**ADDENDUM 01**

Addendum #	01	Date Issued	03/21/2025
Project Name Job #	SWN 0509, Waneta Hall Renovate Restrooms	OSE #	R0325--15X
		EAPC #	20256780
Bid Date Time	April 3, 2025		3:30pm

PROJECT DESCRIPTION
SWN 0509, WANETA HALL RENOVATE RESTROOMS (OSE# R0325--15X)

E303

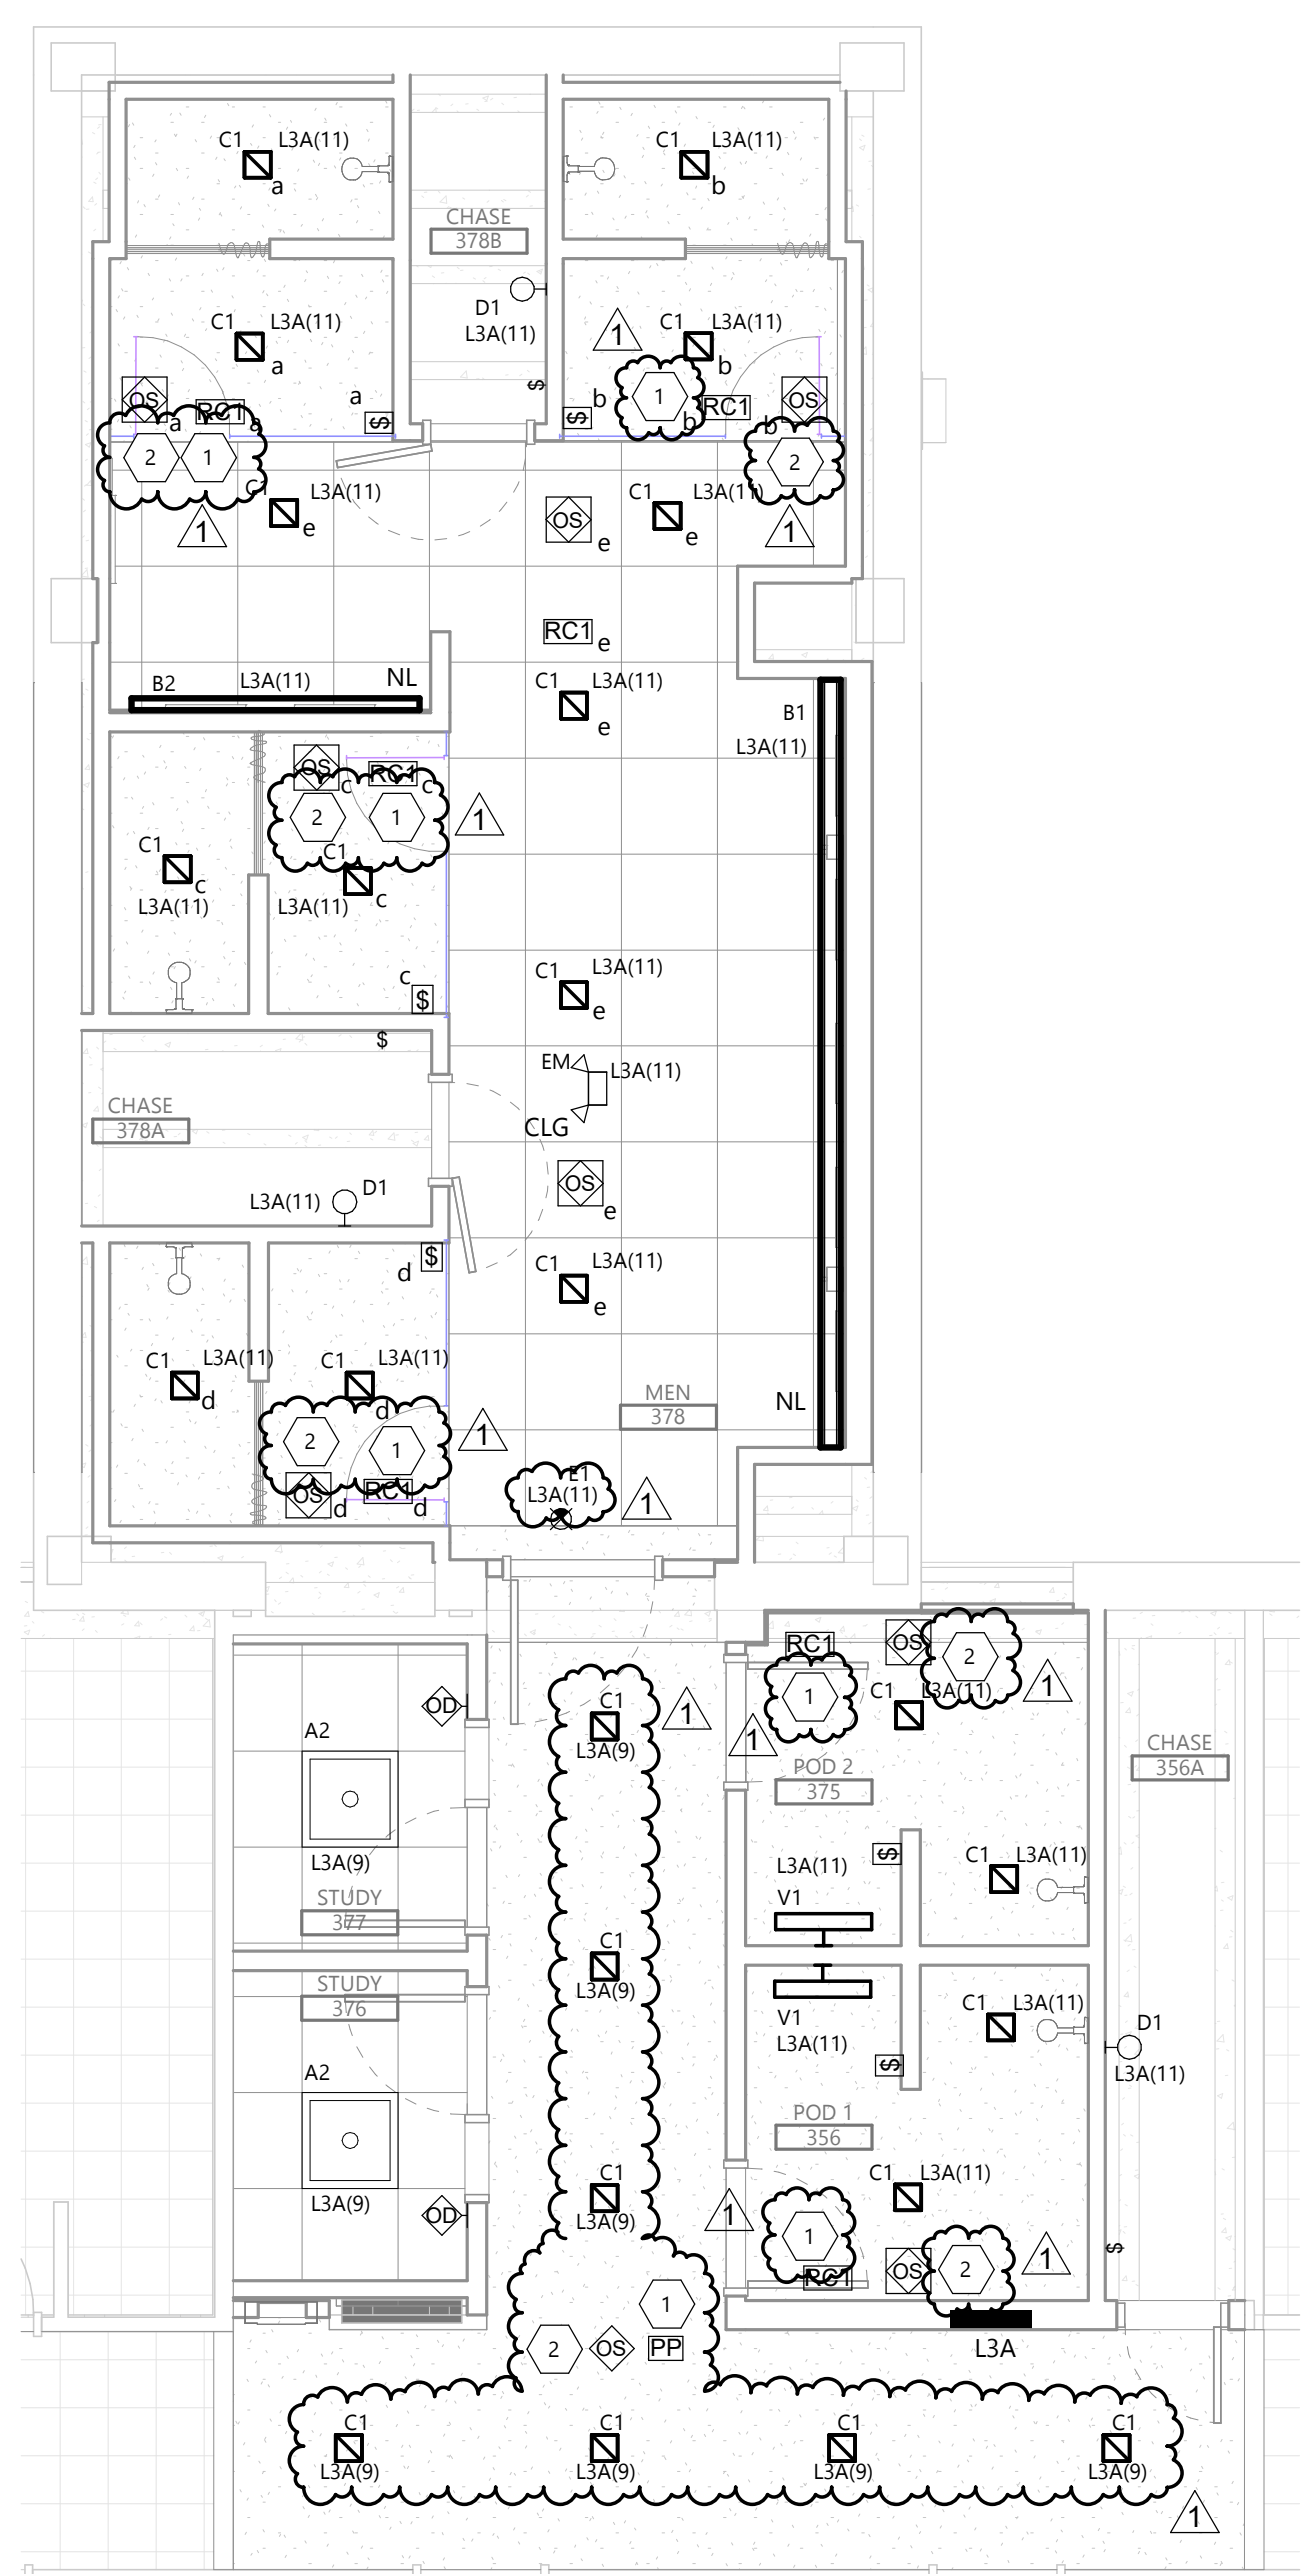
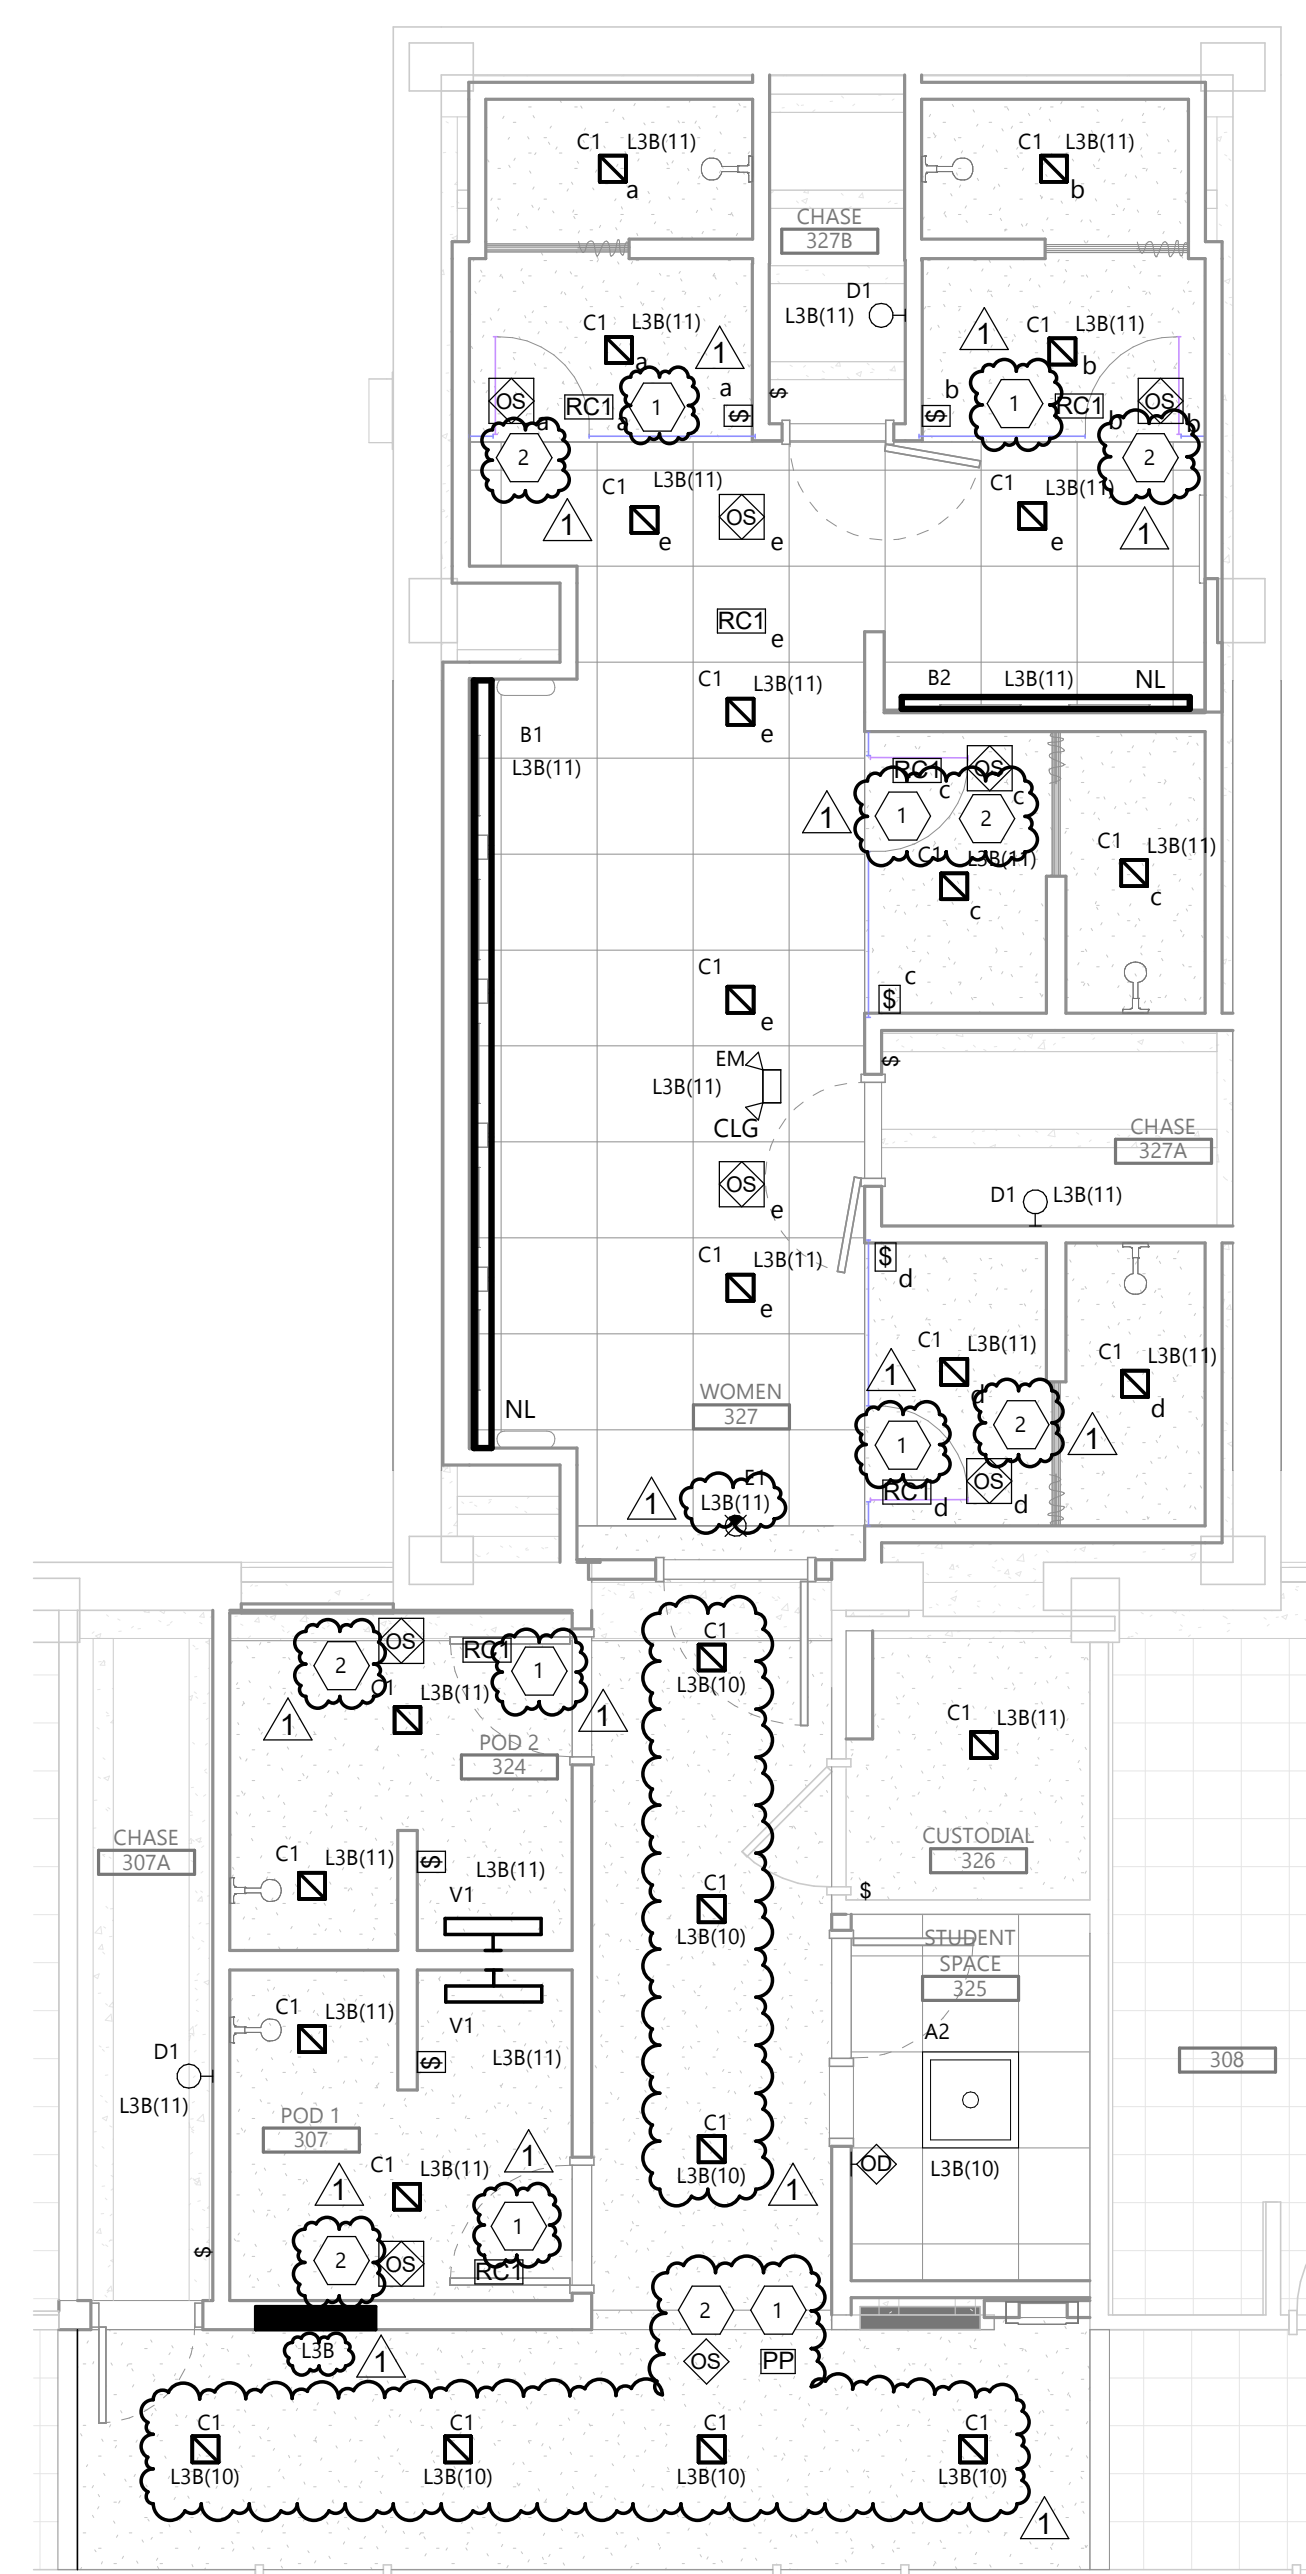
E303	ADD clarification on lighting types and occupancy sensors.
E304	CLARIFIATION on alternates.
E801	REVISIONS to motor and equipment schedules for circuiting.
E802	REVISIONS to schedules.
E901	REVISIONS to schedules.
E902	REVISIONS to schedules.
